Planning Department

MEMORANDUM

Subject: **Application for PCRC Special Permit @ 12 Summer Street (rear)**

Revisions based on 9/23/12 revised plan set.

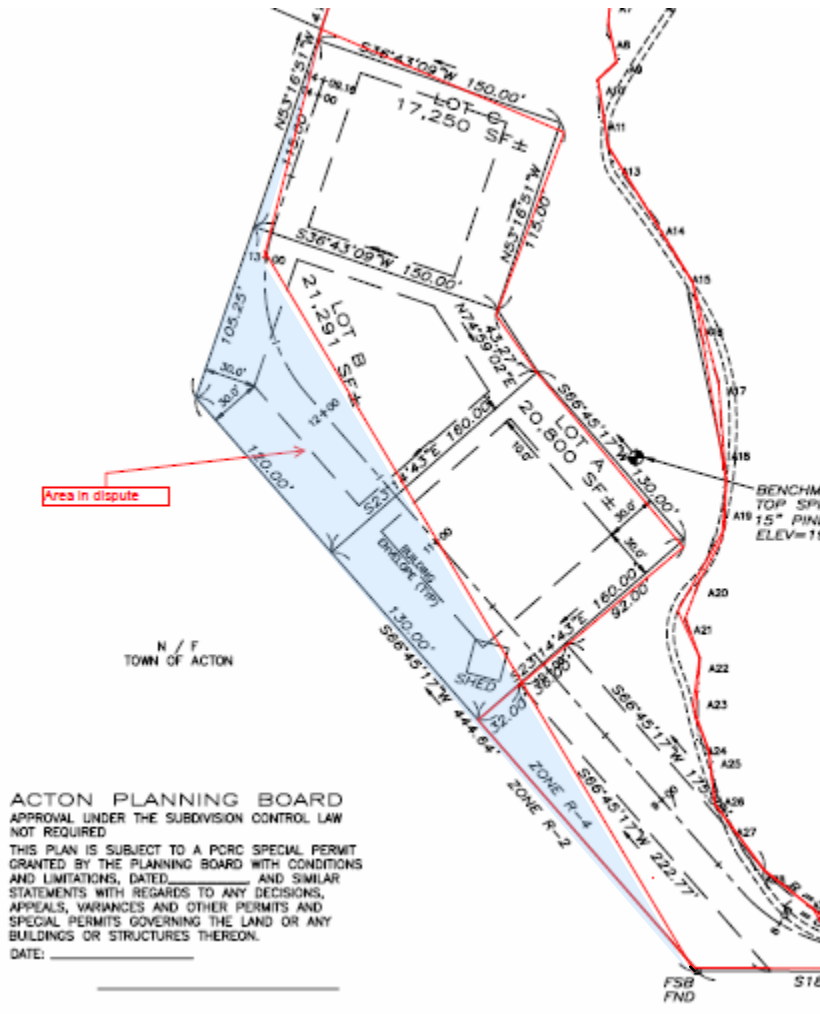
9. ~~However, there is one problem with all this:~~

- ~~— The proposed upland common land area includes the Proposed Common Access Easement, which as shown comprises more than 30,000 square feet.~~
- ~~— Under the rules for the uses of the common land (ZBL, section 9.6.3.2), the Proposed Common Access Easement is not allowed on the common land; it would have to be deducted from the common land total area and the common land upland area.~~
- ~~Even if the Proposed Common Access Easement is narrowed to the minimum required 20 feet (now shown at 30 feet wide or more), the common land calculations would fall far short of the minimum requirements.~~

Addressed. The Proposed Common Access Easement is no longer counted in the common land upland area. Also, see comments on area calculations above.
